## Planning Commission

**Planning Commission Meeting Agenda  
Hartland Township Hall  
Thursday, January 26, 2023  
7:00 PM**

HARTLAND TOWNSHIP PLANNING COMMISSION **DRAFT** MEETING MINUTES

**Subject:** Site Plan #23-001 M-59 Properties Planned Development (PD) Concept Plan

CONCEPTUAL LAND USE PLAN

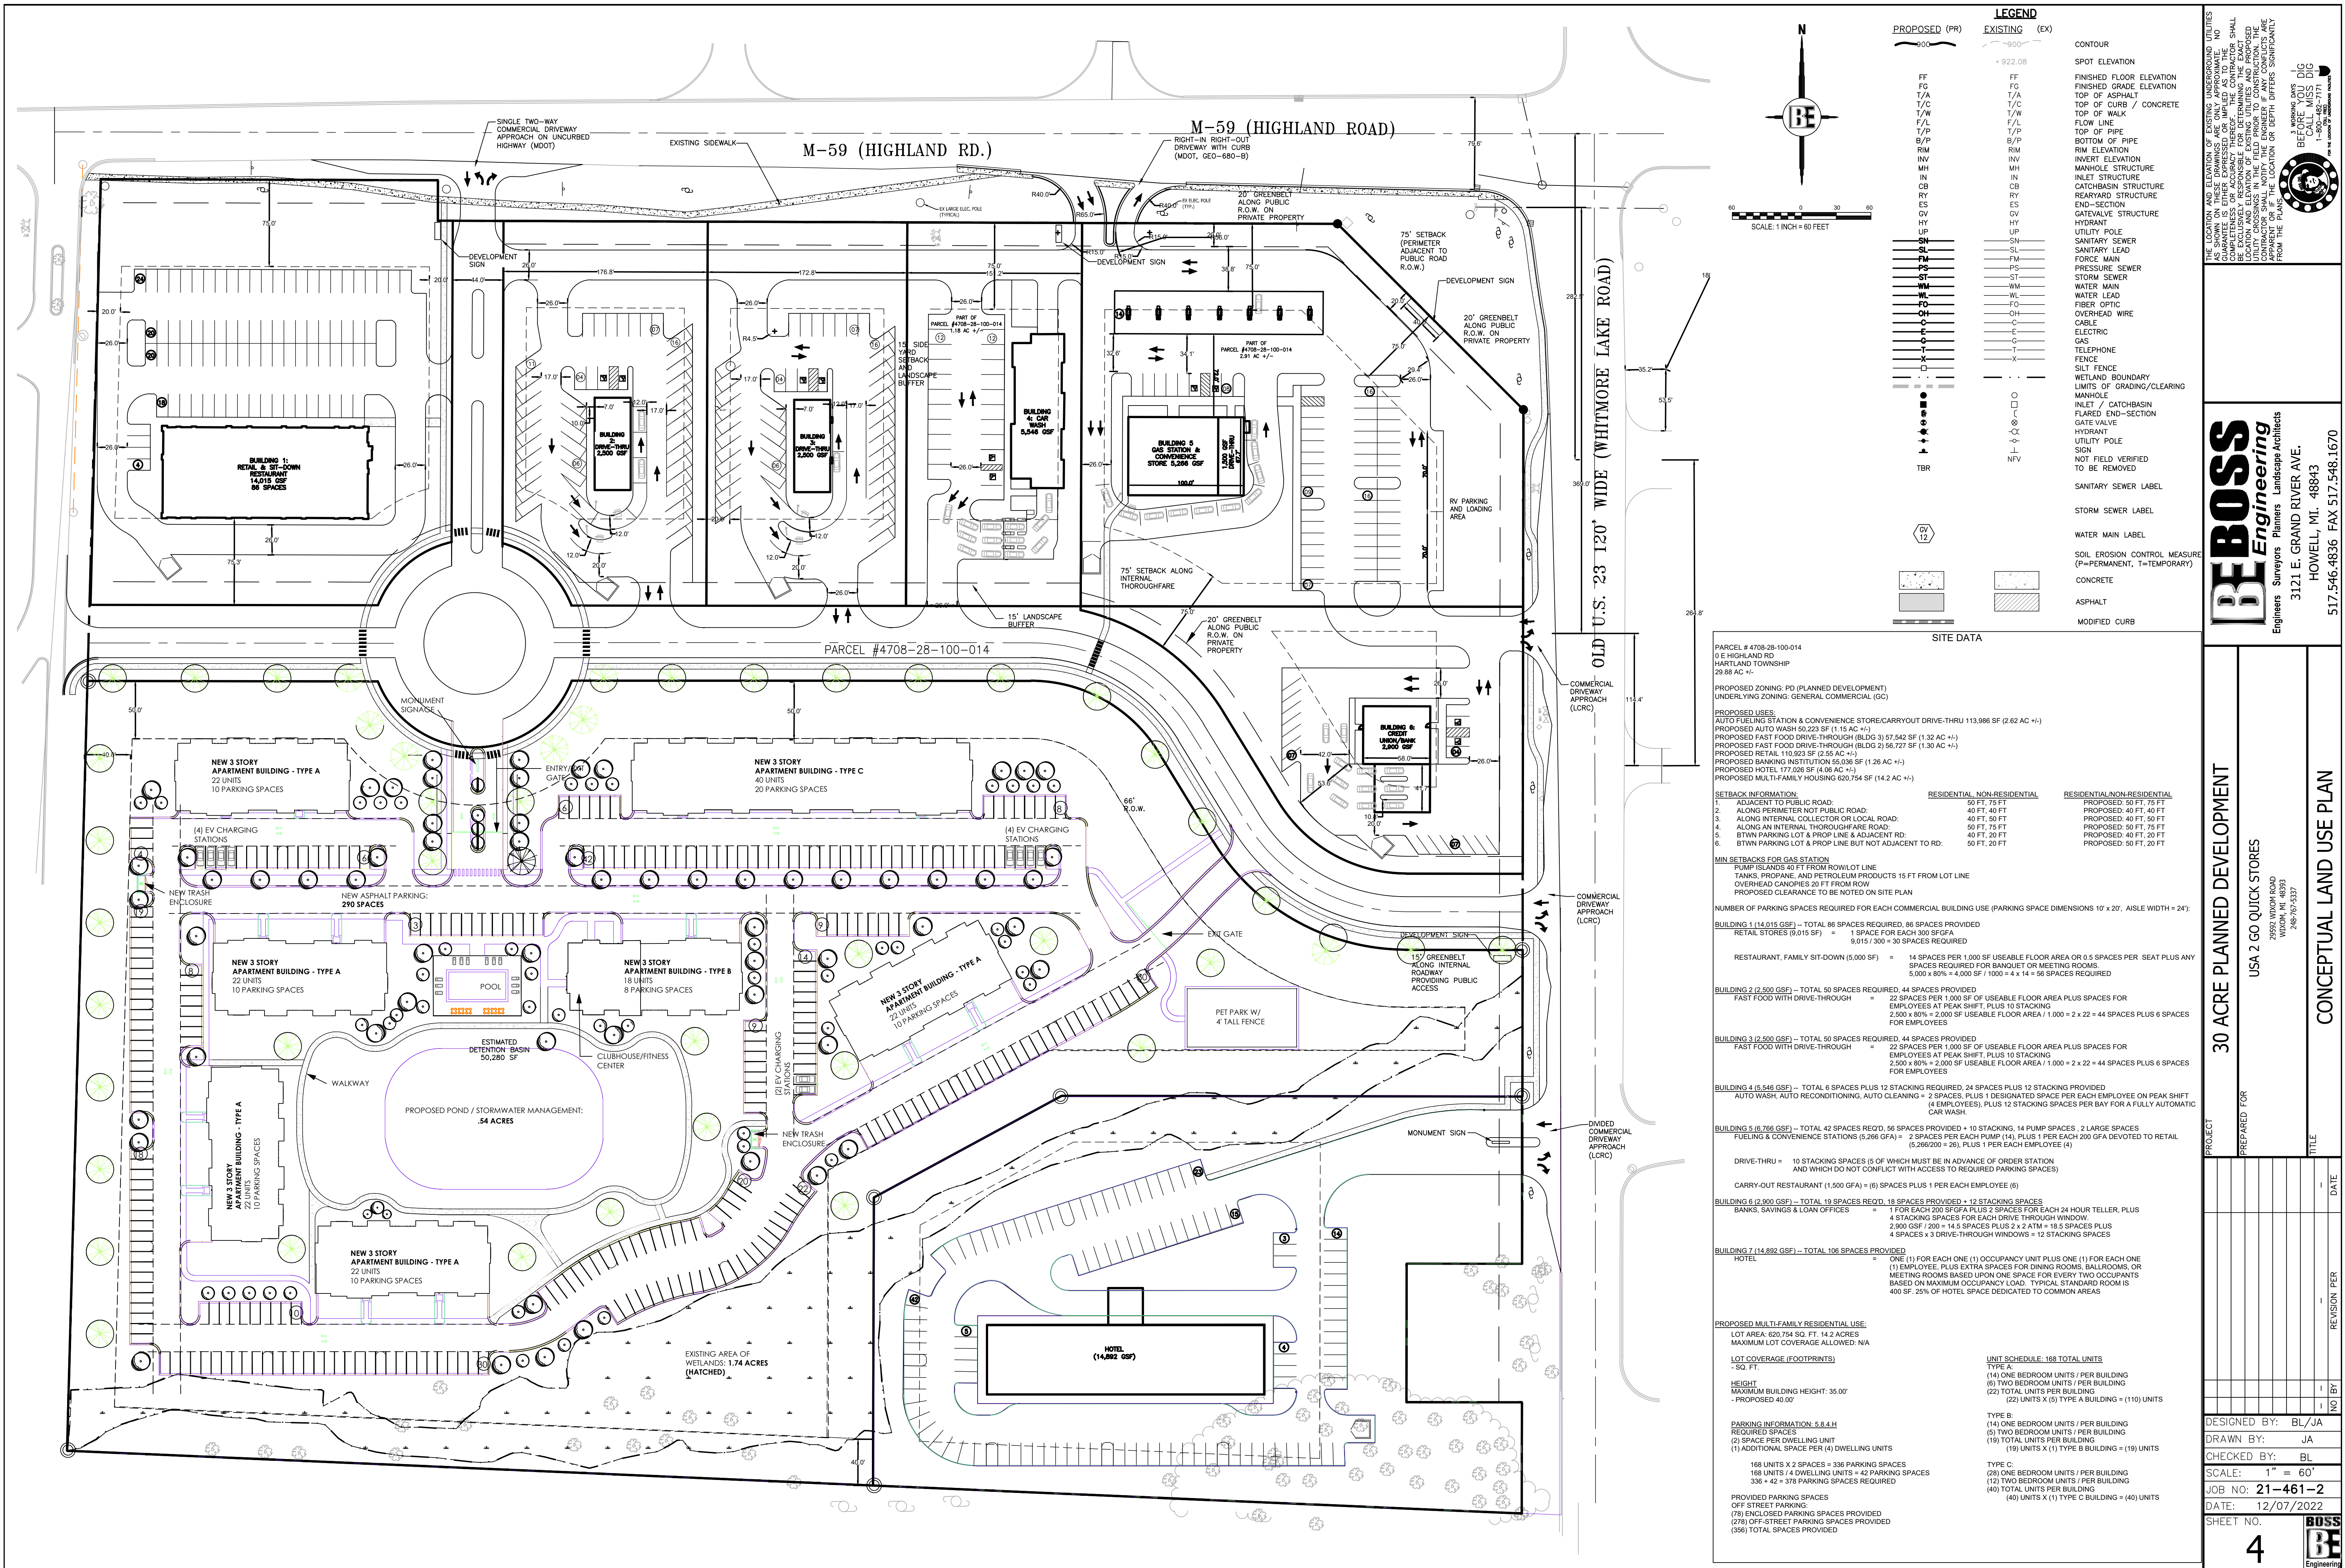
The applicant has submitted a Concept Plan for a mixed use planned development with commercial and residential uses. The commercial sector is situated along the frontage of both Highland Road and Old US-23. The residential portion of the development is internal to the site, south and west of the commercial areas. An internal roadway runs east-west and includes a round-about, which together provide the circulatory network for the development, as well as being a defining boundary of the commercial and residential areas. Additionally, the internal roadway affords vehicular movement from Old US-23 to the internal drive associated with Cheryl Stockwell Academy and LAG Development on the west.

Three (3) development entrances are shown on Old US-23 and provide access to commercial sites on the north and along Old US-23. A bank/credit union building is shown with access from the most northern entrance drive off Old US-23. The internal roadway is the middle entrance drive. A hotel is shown at the southern end of the site, with access from Old US-23.

The plan shows five (5) conceptual outlots along the frontage of Highland Road. The following businesses/uses are shown, as possible options: two (2) fast food restaurants each with drive-through service; one (1) multi-tenant building (sit-down restaurant and retail); one car wash; and one (1) automobile fueling station. Along Old US-23, a bank/credit union building with drive-through service and a hotel are shown as possible businesses.

Garage parking is included in each apartment building. Off-street parking is shown around each apartment building. Although not shown on the plans, the applicant has mentioned an interest in having carports as part of the project.

SHEET NUMBER  
C400

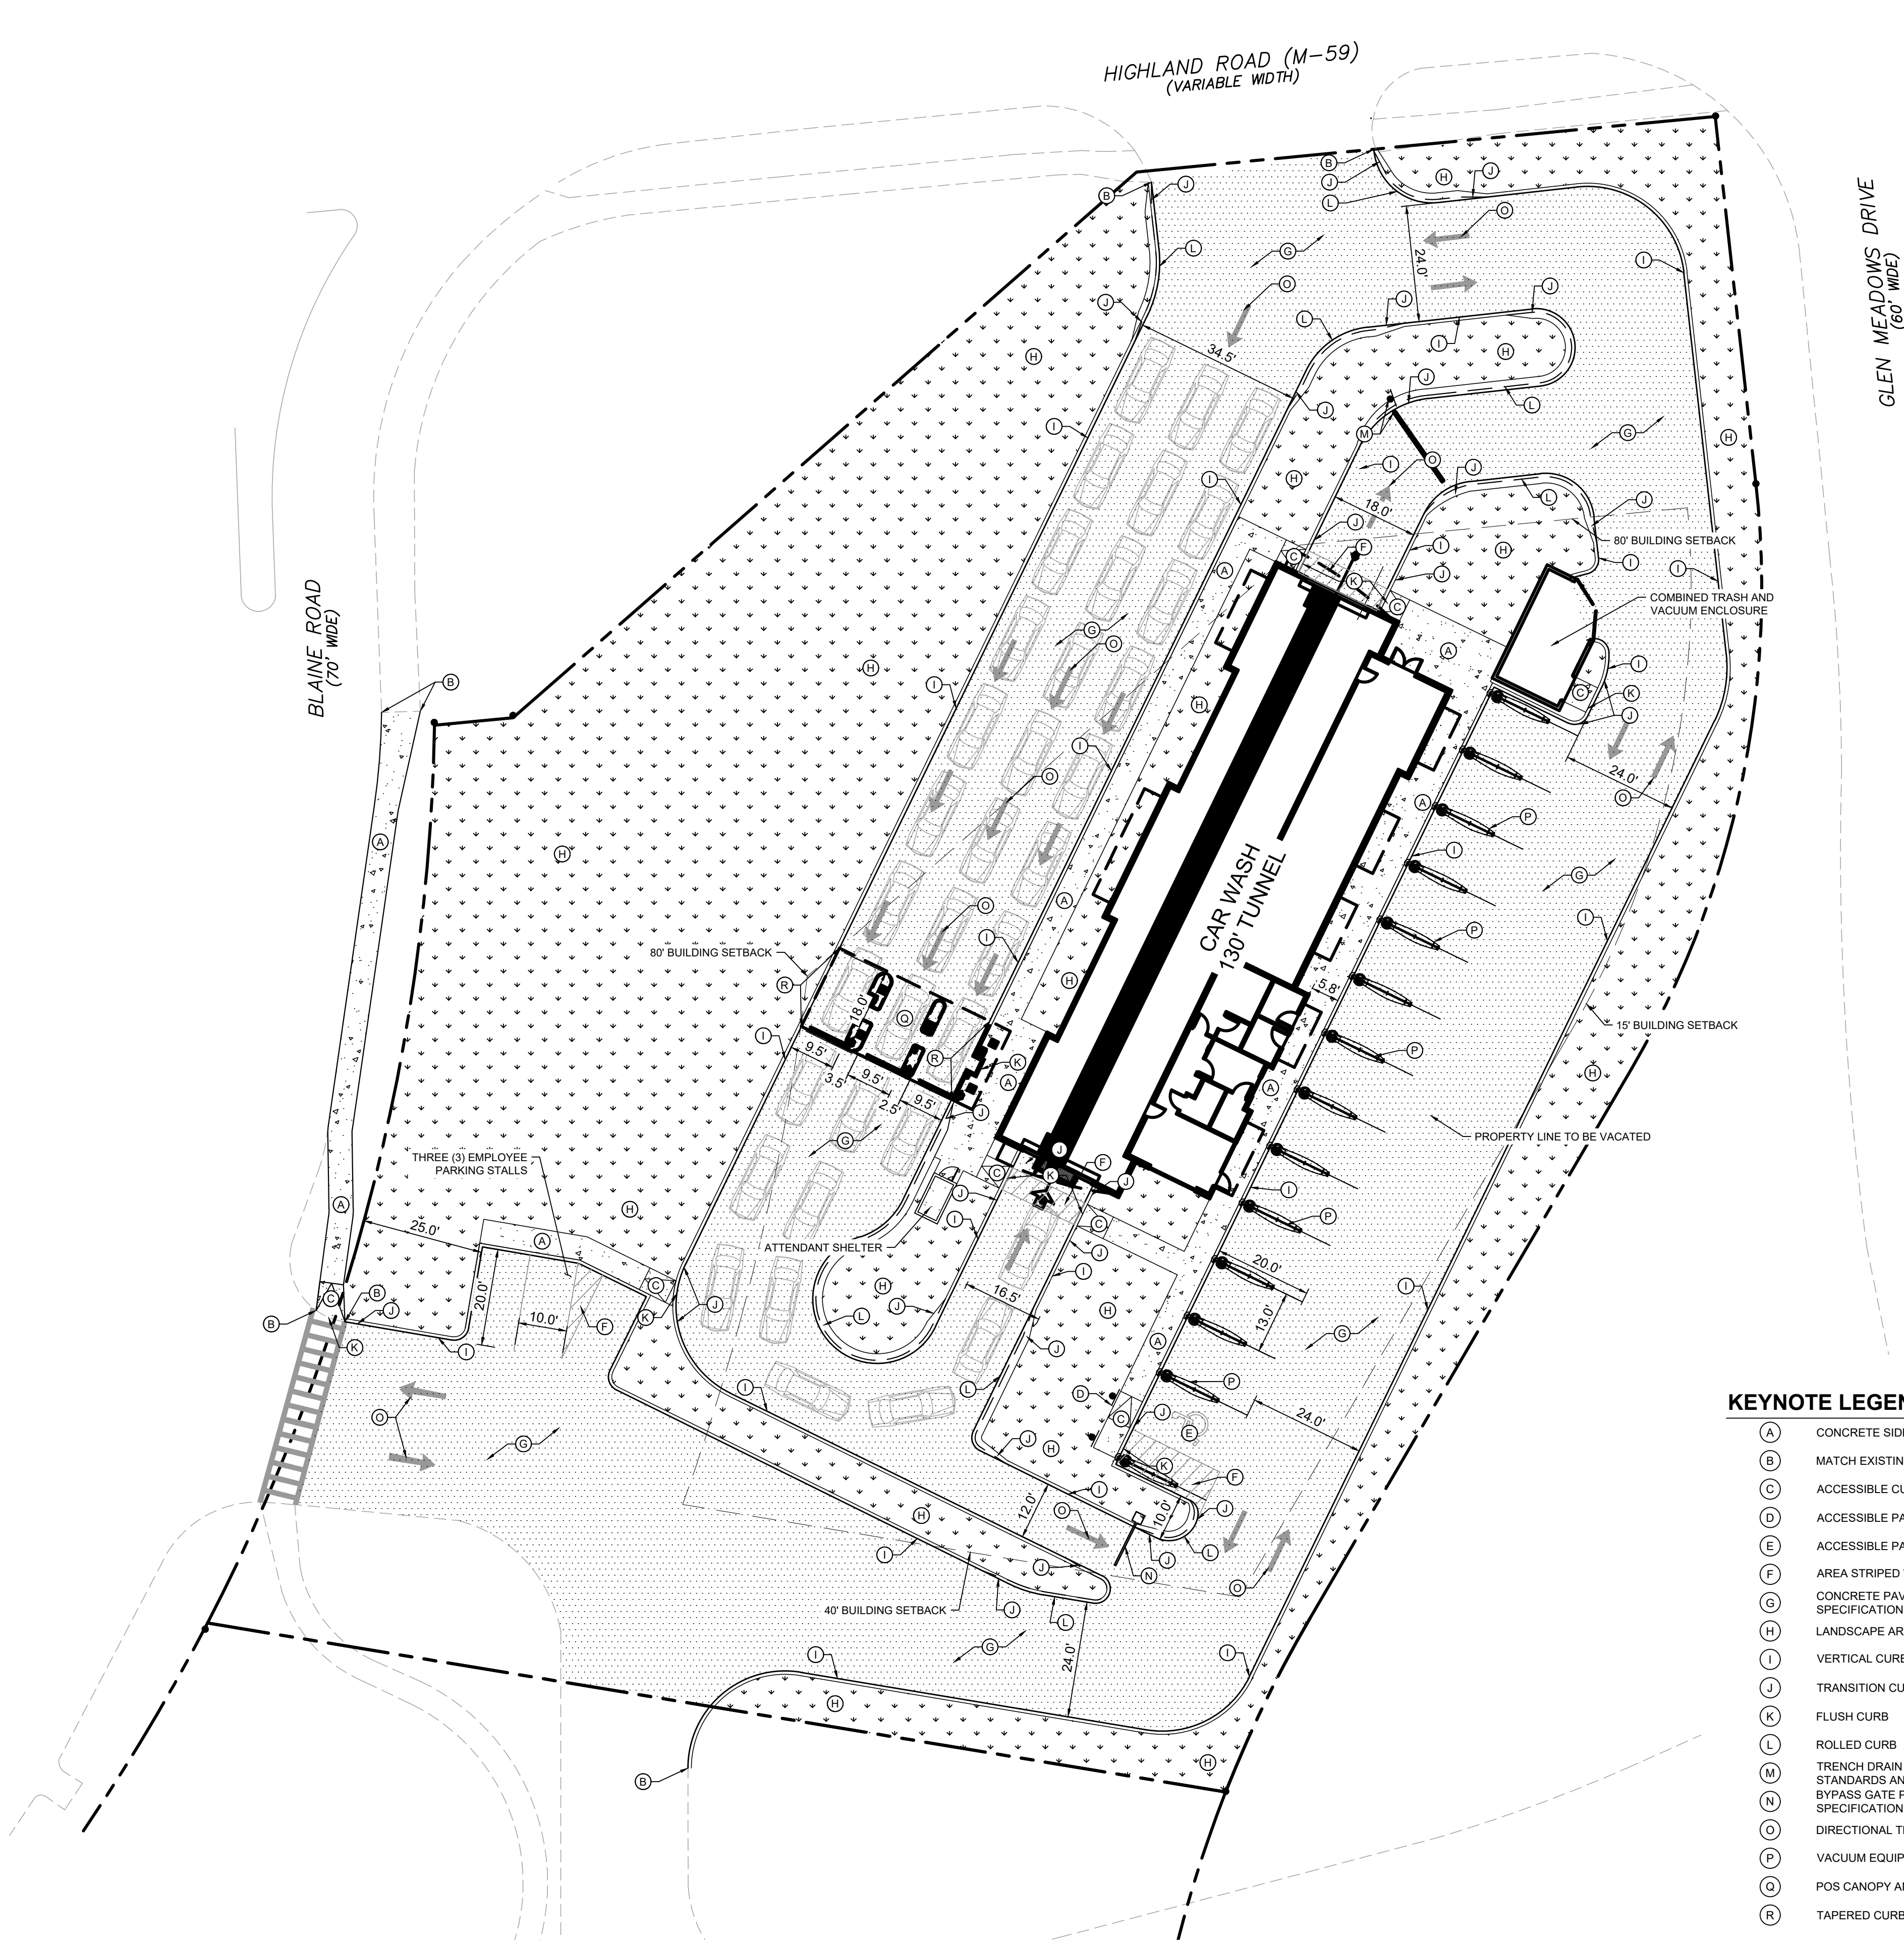
On October 20, 2022, the Planning Commission discussed the location of the vacuuming equipment, which was shown in the front yard, between the car wash building (west elevation) and the street right-of-way line of Blaine Road. Per Section 4.17 of the Zoning Ordinance, vacuuming activities are permitted in the side or rear yard only. Although the number of vacuuming devices had been reduced on the plans dated October 6, 2022, all vacuuming devices were located in the front yard. It was the consensus of the Planning Commission that vacuuming devices are not permitted in the front yard per the Ordinance, no matter what

style of equipment, thus the Planning Commission could not approve the plan as presented. The Planning Commission offered an option to the applicant to revise the plans and come back to the Planning Commission, which is what the applicant chose to do.

- Building size reduced from 6,500 square feet to 5,425 square feet.
- One (1) combined trash/vacuum enclosure is proposed, versus two (2) enclosures on the previous plans.
